# 254 Adderly Road

REV. 4 - COMPREHENSIVE LETTER STAFF COMMENT RESPONSE

Site Plan A100

1 Site Plan  
A100 Scale: 1:300

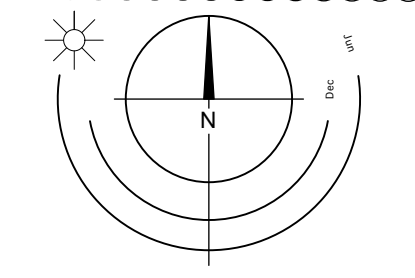
REV #	DATE	DESCRIPTION
1	10-Aug-22	- RE-ISSUE FOR DP IN RESPONSE TO CITY FEEDBACK
2	8-Nov-22	DAP RESPONSE IS AS FOLLOWS: - INCREASE DISTANCE BETWEEN BUILDINGS 4 & 6 - ADD CURVES TO LOWER DRIVE AISLE - PERMEABLE PAVING - CONTINUITY OF PEDESTRIAN PATH. SEE LANDSCAPE
3	8-Jun-23	- COMPREHENSIVE LETTER RESPONSE
4	19-Sep-23	STAFF COMMENTS RESPONSE - UPDATED PROJECT DATA PROVIDED (A002) - KEYNOTE LEGEND UPDATED (A100, A200-A202) - E.V. CHARGING KEYNOTE 'C' ADDED FOR CLARIFICATION - ADDITIONAL TYPICAL DIMENSIONS PROVIDED AS PER CLAUSES 4.1., 4.3., & 5.5. (A100, A200-A202)
